Memorandum

Date: December 9, 2020
To: Karen Hong, Stanford Lands, Buildings and Real Estate
From: Ellen Poling, Fehr & Peers
Subject: Responses to AECOM Peer Review of the LBRE Replacement Building Resubmittal

This memorandum transmits draft responses to the comments in AECOM's October 28, 2020 peer review of the LBRE Replacement Building resubmittal.

Chart 1: AM Peak Hour Volume Comparison

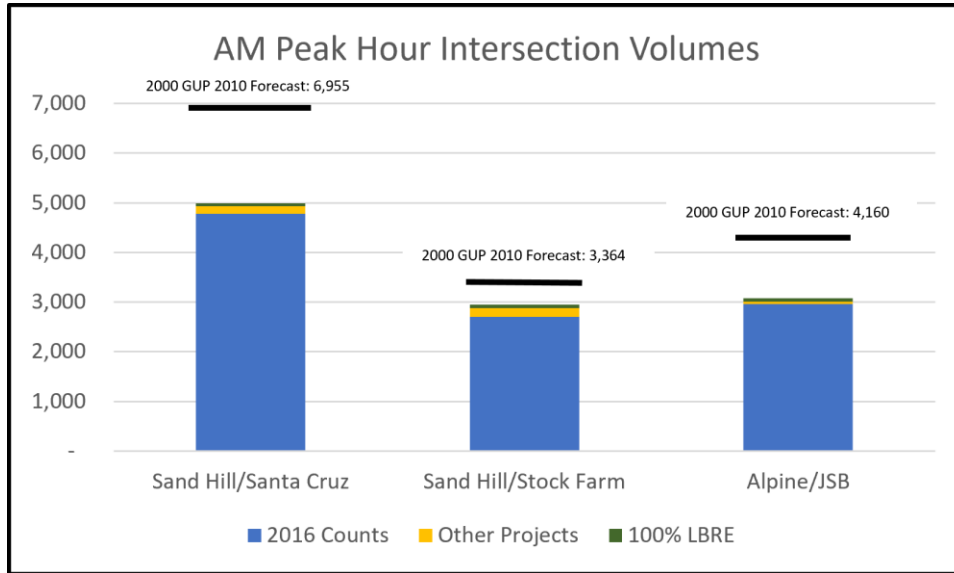
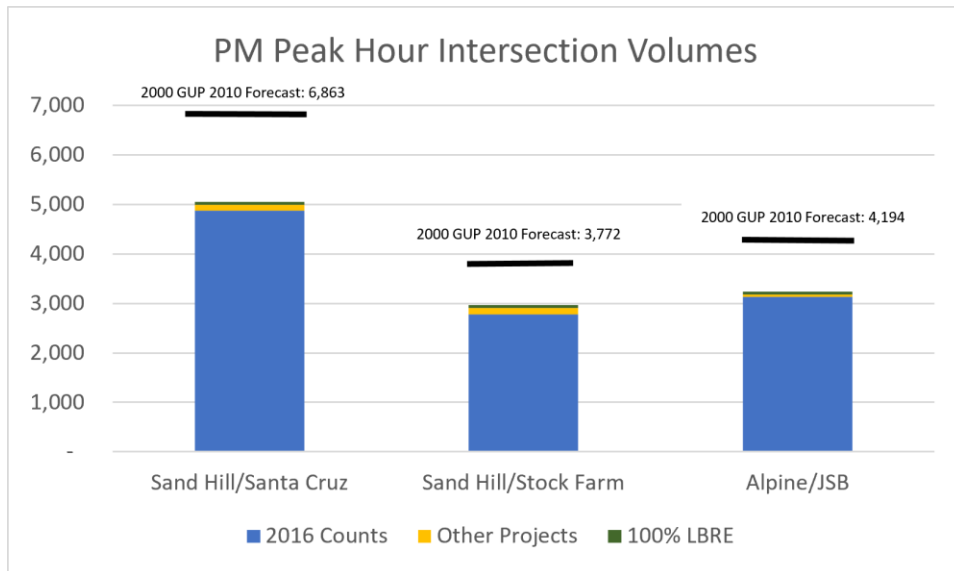
Comment RI-3, Part 2: In addition, AECOM recommends that the County require the intersections requested by Menlo Park including Sand Hill and Alpine Roads considering both regular vehicles and heavy truck traffic to determine the impact of this project, if any, due to the re-routing of trips. Additional intersections suggested by AECOM and/or Menlo Park include:

- Stock Farm and Sand Hill Roads
- Sand Hill Road and Santa Cruz Ave
- Alpine Road and Junipero Serra Blvd
- Alpine Road and Alpine Access Road/Piers Lane

While additional external intersection analysis is not required by the 2000 GUP conditions of approval, Fehr & Peers has performed a sensitivity analysis to show that even under extreme worst-case conditions assuming that every trip associated with the LBRE building, using 2000 GUP EIR trip generation rates, is a newly added trip at the intersections referenced by AECOM¹, the

impacts at the intersections would not exceed the impacts that were identified in the 2000 GUP EIR. Again, this is a highly conservative analysis given that (a) the work schedules of many of the LBRE employees necessitate commuting outside the AM and PM peak hours; (b) some LBRE employees likely use the Sand Hill Road corridor today to access the existing facilities at Bonair; and (c) some other employees currently using the Searsville lot will shift to other lots in the Central or East Campus Districts.

For this sensitivity analysis, Fehr & Peers estimated the total traffic generated by the LBRE Replacement Building Project using staff trip generation rates from the 2000 GUP EIR; added the two peak hour external truck round trips projected in the LBRE Replacement Building Local Access and Circulation Study; and added 100 percent of the Project trips to the 2016 peak hour volumes at Sand Hill Road/Stock Farm Road, Sand Hill Road/Santa Cruz Avenue, and Alpine Road/Santa Cruz Avenue/Junipero Serra Boulevard. We also included traffic projections from three projects in the West Campus area and Menlo Park – the Stanford Hospitals Renewal and Replacement Project, the Center for Academic Medicine Project, and the Middle Plaza Project. Note that a 2019 count at Sand Hill Road/Santa Cruz Avenue/Junipero Serra Boulevard showed slightly lower volumes than the 2016 counts, so we used the higher 2016 counts for this intersection rather than the later count.

Table 1 presents the trip generation estimate, and Charts 1 and 2 show the resulting combined volume (2016 counts + other projects + extreme worst case LBRE Replacement Building project). The total volume at each intersection is well below the 2010 volume forecast in the 2000 GUP EIR.
